# Town of Gorham Planning Board Meeting January 9, 2023

**ITEM 7-** <u>Pre-Application Discussion – Site Plan - Patriot Holdings, LLC</u> – a request for approval to construct an approximately 10,000 sf building for commercial retail and twelve 8,000 sf self-storage buildings. Zoned, Roadside Commercial (RC). Map 77, Lot 5. The applicant is represented by Chris Taylor, P.E., with Sebago Technics, Inc.

## 4. STAFF COMMENTS

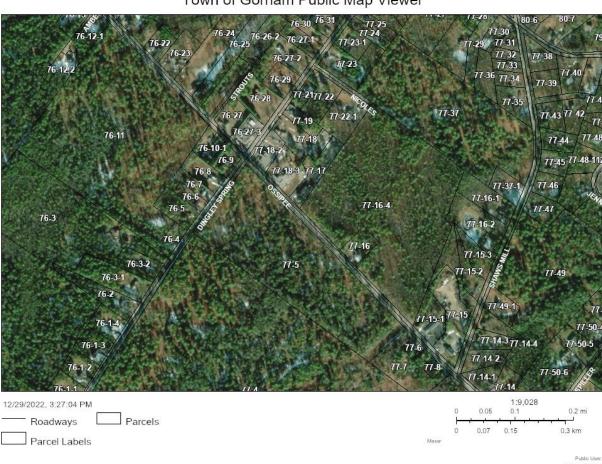
Wetlands are shown on the site in the Gorham GIS inventory, on the Beginning with Habitat maps provided by Maine Inland Forestry and Wildlife, as well as on the sketch plan provided with the submission. No critical wildlife habitat was shown on the site in data inventories.

The site is shown as part of the 10-50 gallons per minute aquifer area.
